# **environmental statement**

**DUANE ARNOLD ENERGY CENTER**

**DOCKET NO. 50-331**

**March 1973**

Fig. 3.10. Liquid Radioactive Waste Flow Diagram.

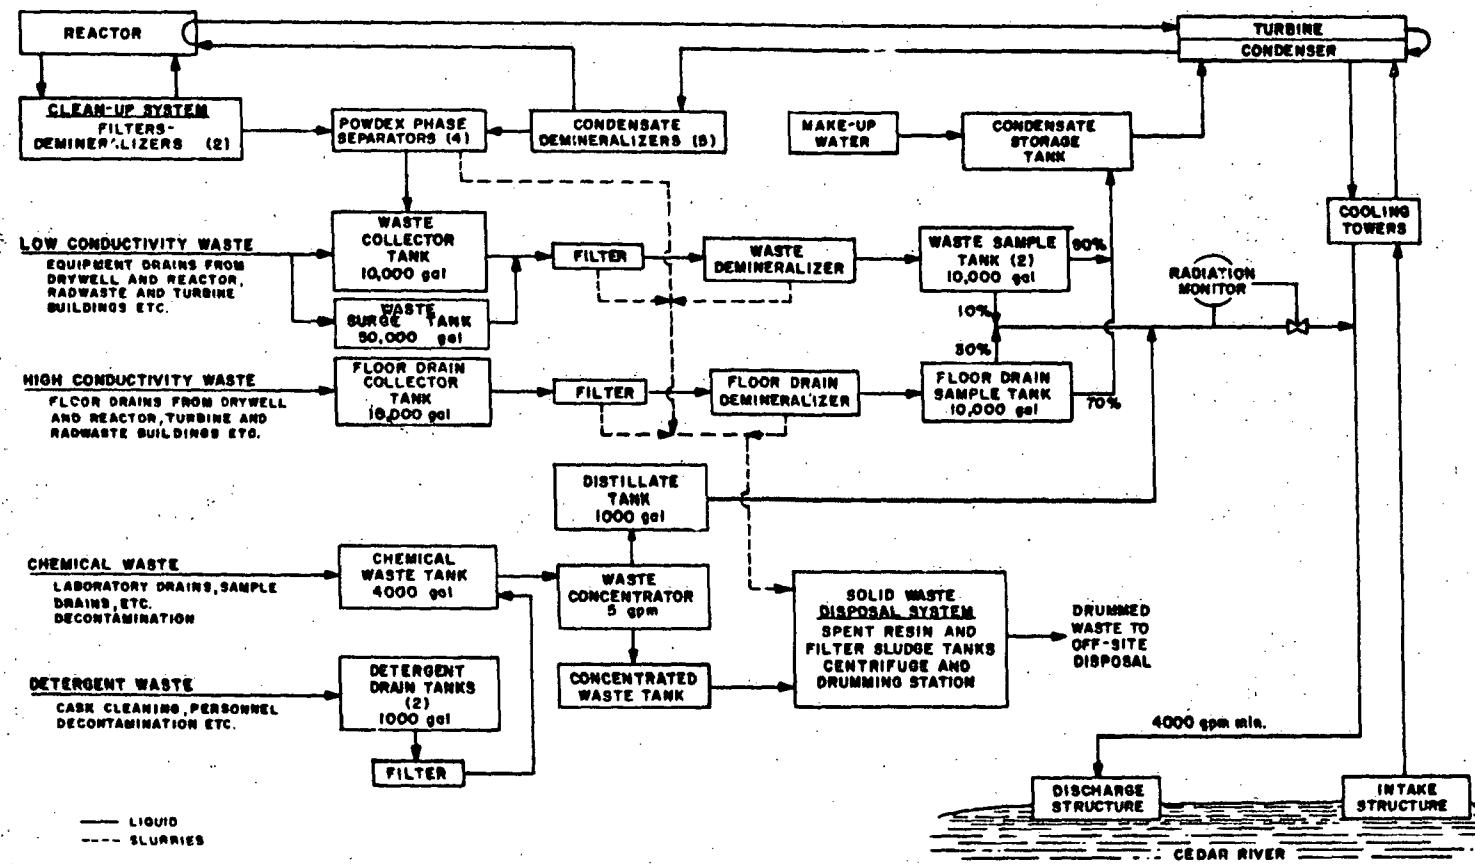
Figure 3-10. The figure does not show bypass of the radwaste evaporator for chemical waste and detergent drains. Bypass of the radwaste evaporator is addressed in Amendment 10, question 9.24 of the DAEC FSAR.

Fig. 3.12. Transmission Lines for DAEC.

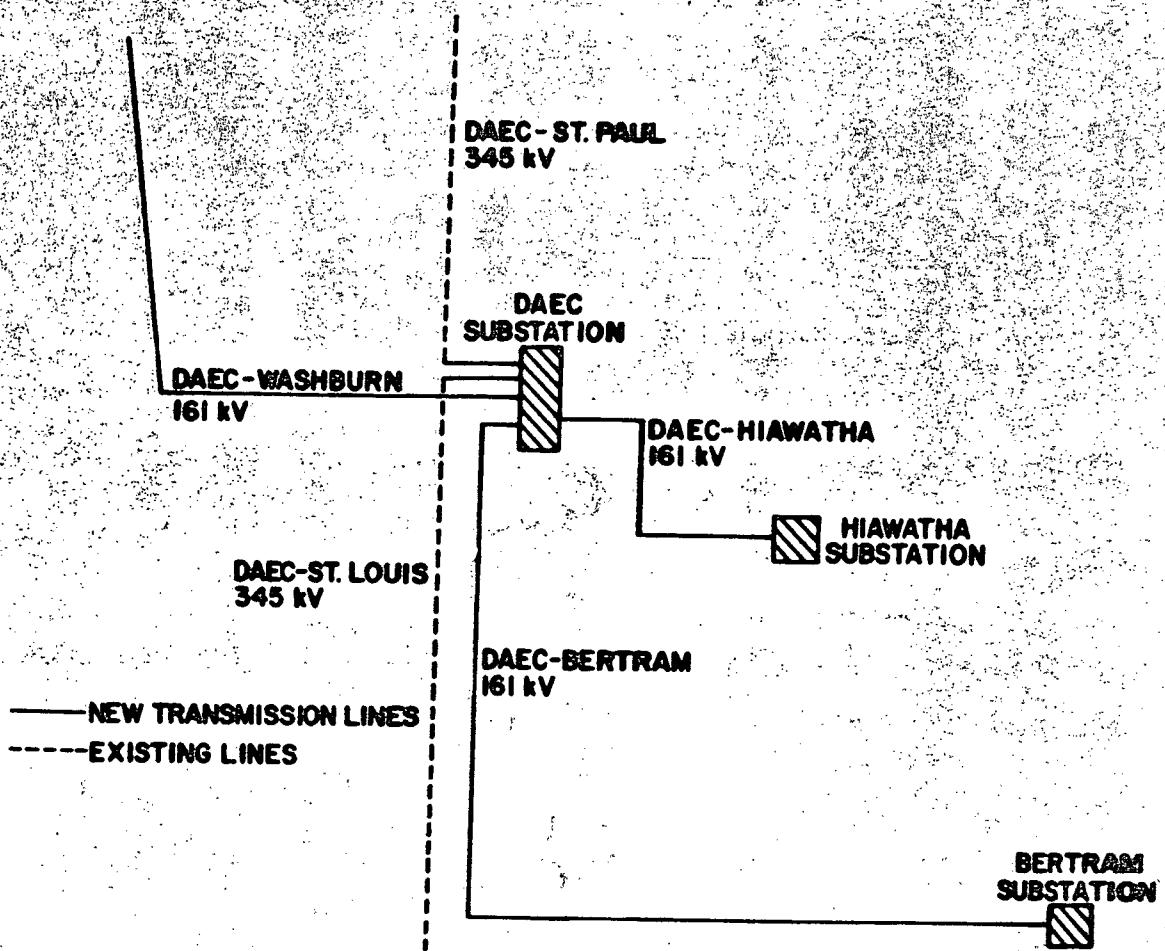
Figure 3.12. The Beverly substation will not be a part of the DAEC transmission lines at the time of energizing DAEC. The Beverly substation should be omitted from this figure and the title of the line changed to "DAEC - Bertram 161 KV". The Beverly substation will be used to support and enhance the reliability of the southwest quadrant of the Cedar Rapids metropolitan area and rural towns and farms. This substation will serve Iowa Electric and Rural Electric Cooperative sub-transmission substations. The Beverly sub is part of the integrated transmission network of Iowa Electric and other Iowa utilities. The substation is required to distribute power from the existing 345 KV line and is not dependent upon the DAEC generation.

Fig. 5.1. Noise Criterion "NC" Curves. The octave band sound pressure levels associated with the noise criterion conditions of Table 5.2. Modified from Ref. 3.

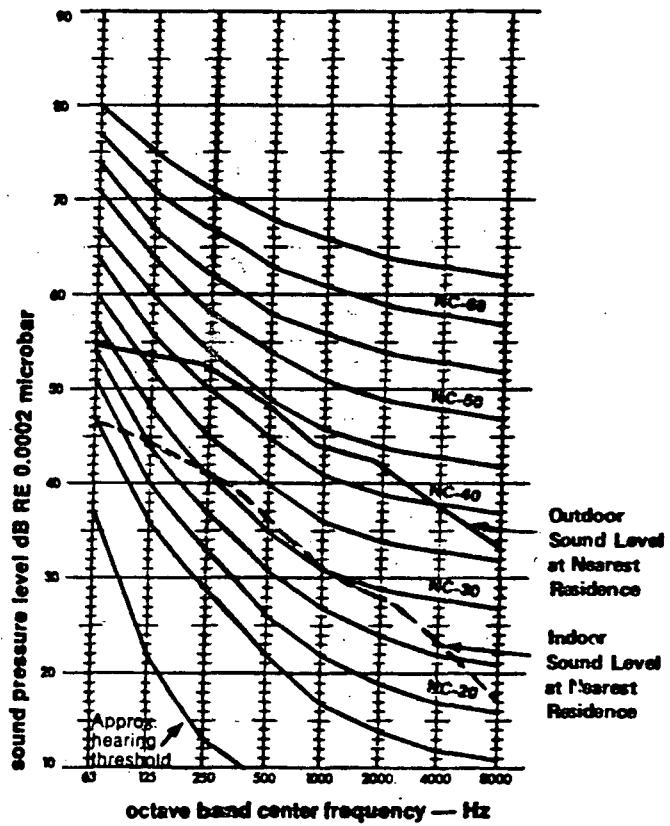
Under the discussion of noise affects, it states that a minimum of 10 db attenuation can be assumed to be provided by the walls of the typical house. It is felt that to correctly illustrate these noise levels, Figure 5.1 on page 5-3 should include this 10 db attenuation for the plotting of noise levels indoors.
